**TOWN OF MOUNTAIN VILLAGE
DESIGN REVIEW BOARD REGULAR MEETING
THURSDAY OCTOBER 1, 2015, 10:00 AM
2nd FLOOR CONFERENCE ROOM, MOUNTAIN VILLAGE TOWN HALL
455 MOUNTAIN VILLAGE BLVD, MOUNTAIN VILLAGE, COLORADO
AGENDA
REVISED**

3.	10:05	30	Jameson	Action	Consideration of a Design Review Process Development Application for new construction of a single-family residence on Lot BC513AR

**PLANNING AND DEVELOPMENT
DEPARTMENT**

PROJECT NAME: DENESIK RESIDENCE MOUNTAIN VILLAGE, COLORADO 81435	PROJECT NAME: MOUNTAIN VILLAGE
SHEET DESCRIPTION: OVERALL SITE PLAN	SHEET NUMBER: A-100

Grading
and
Drainage
Plan

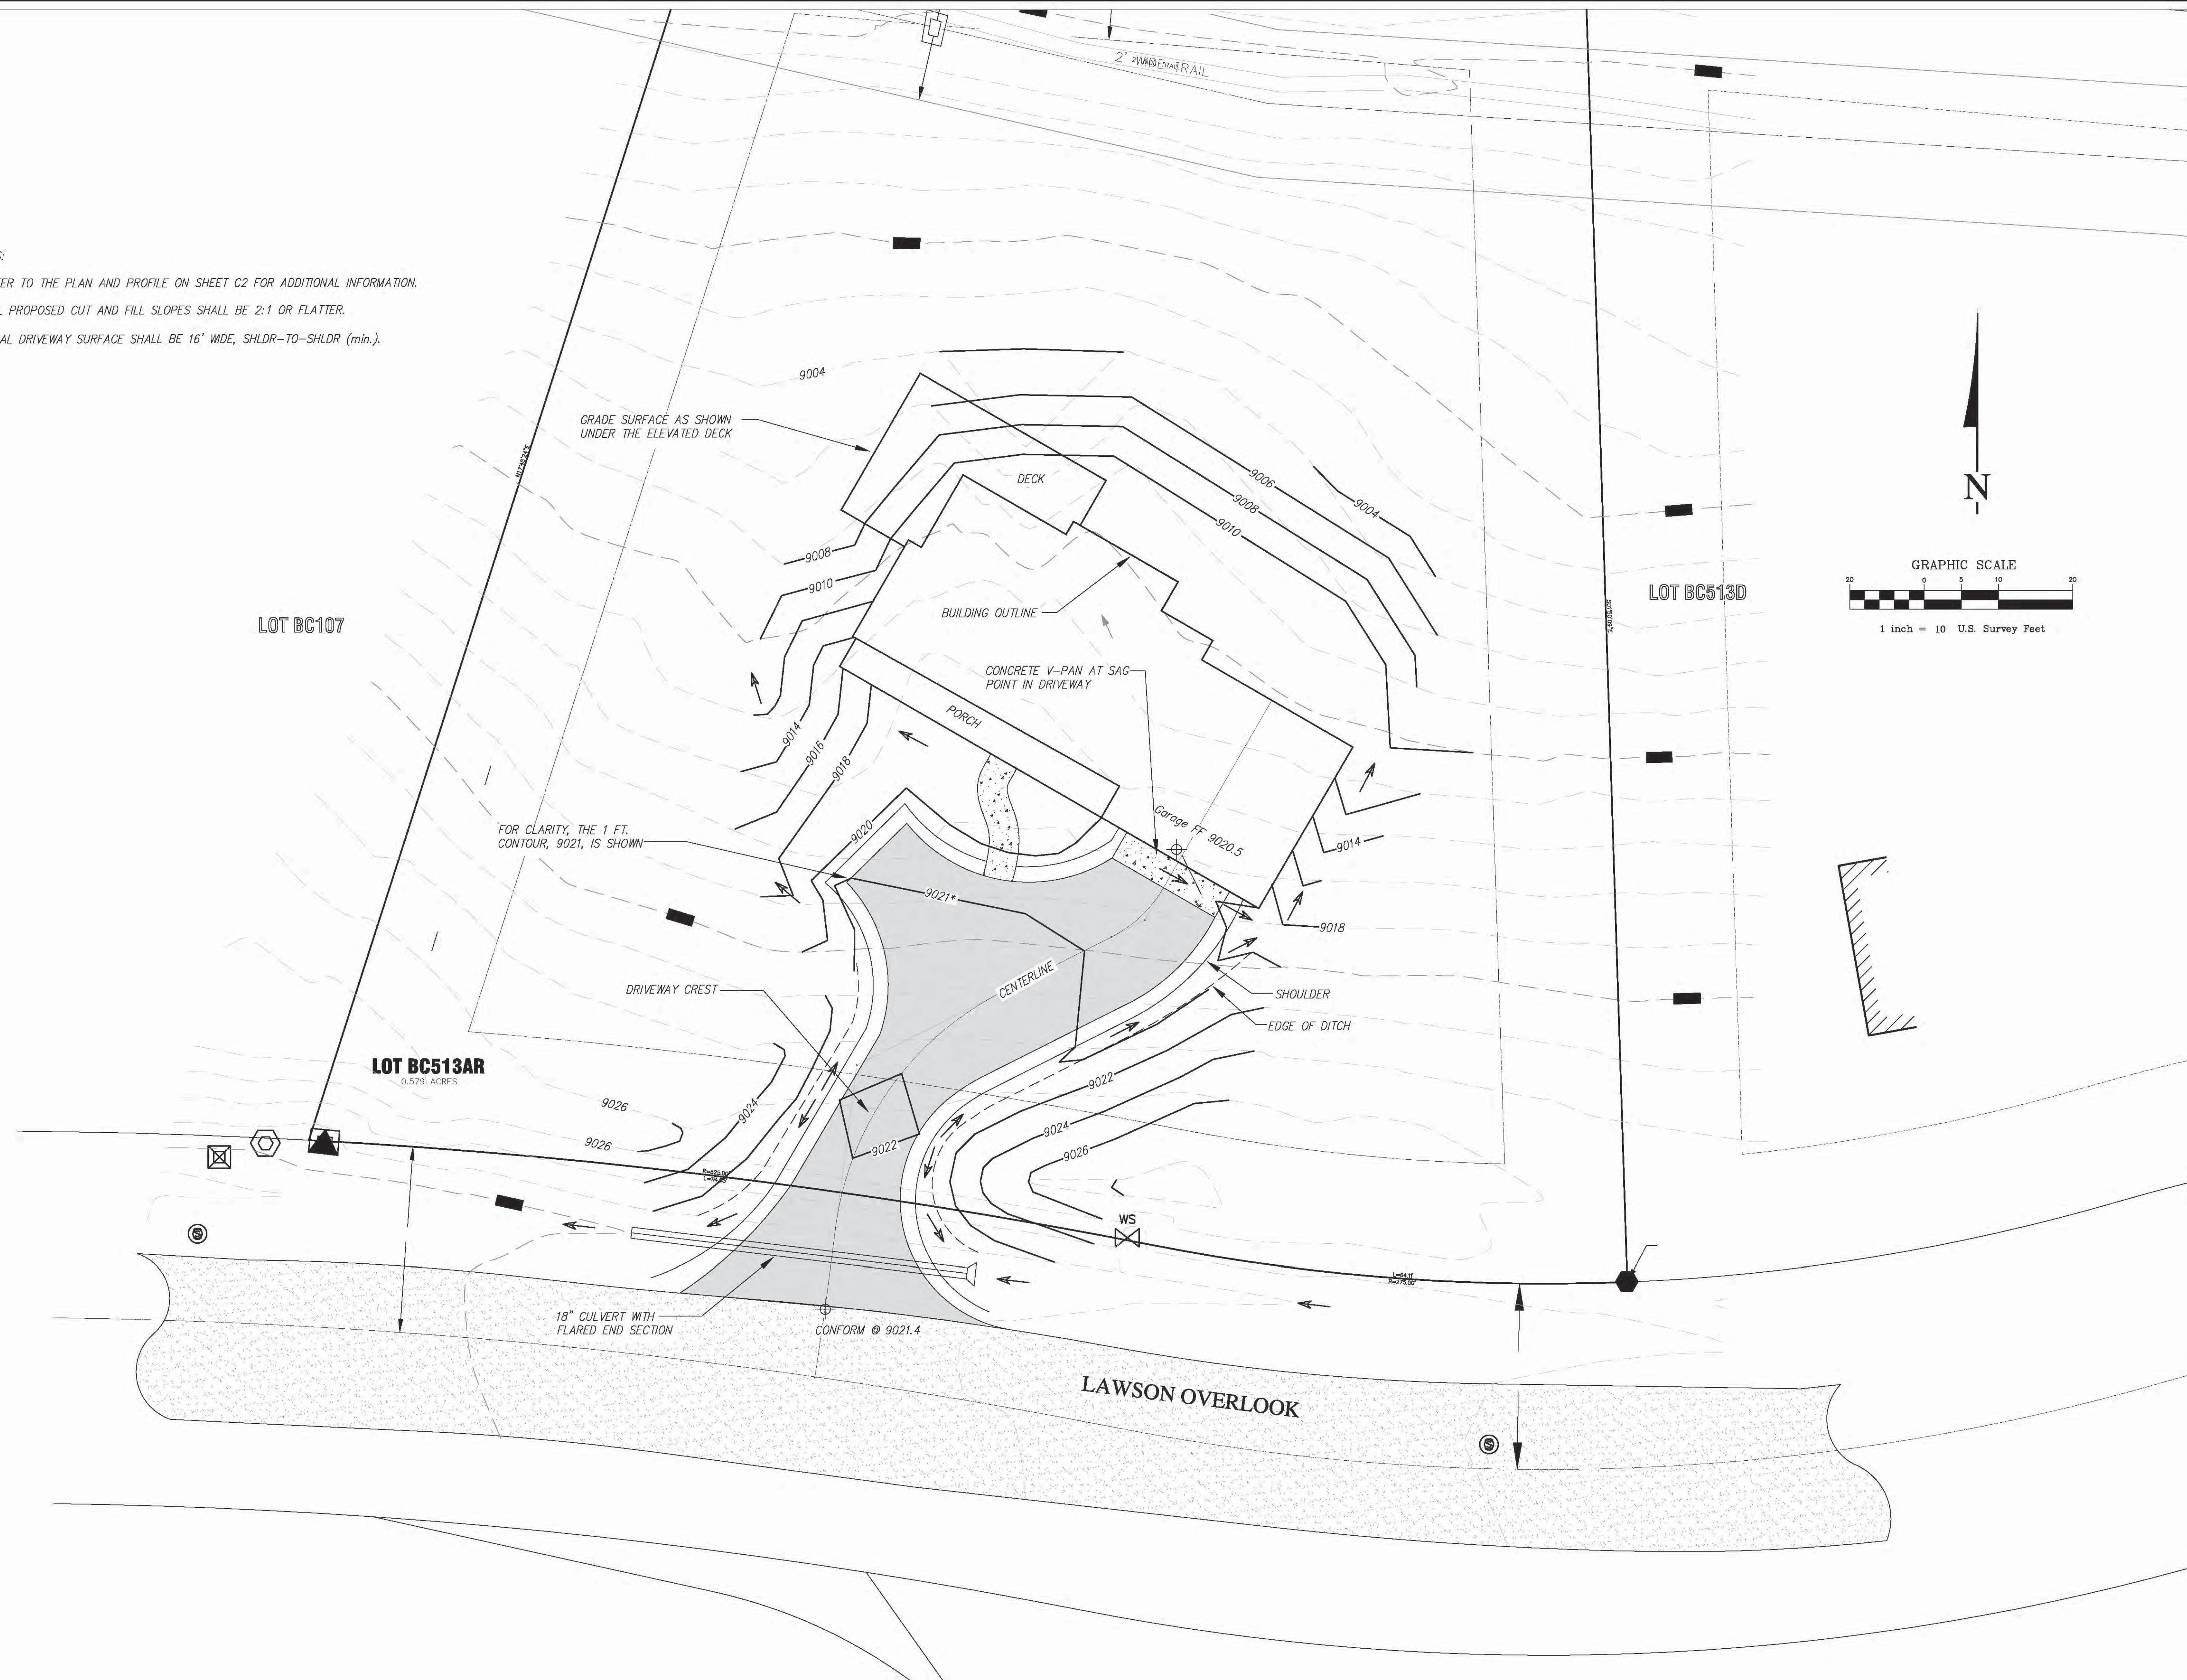
The applicant has provided a grading and drainage plan prepared by Uncompahgre Engineering for the proposed development. Positive drainage away from the structure has been created. The plan includes piping within the General Easement and Setbacks. Such permanent
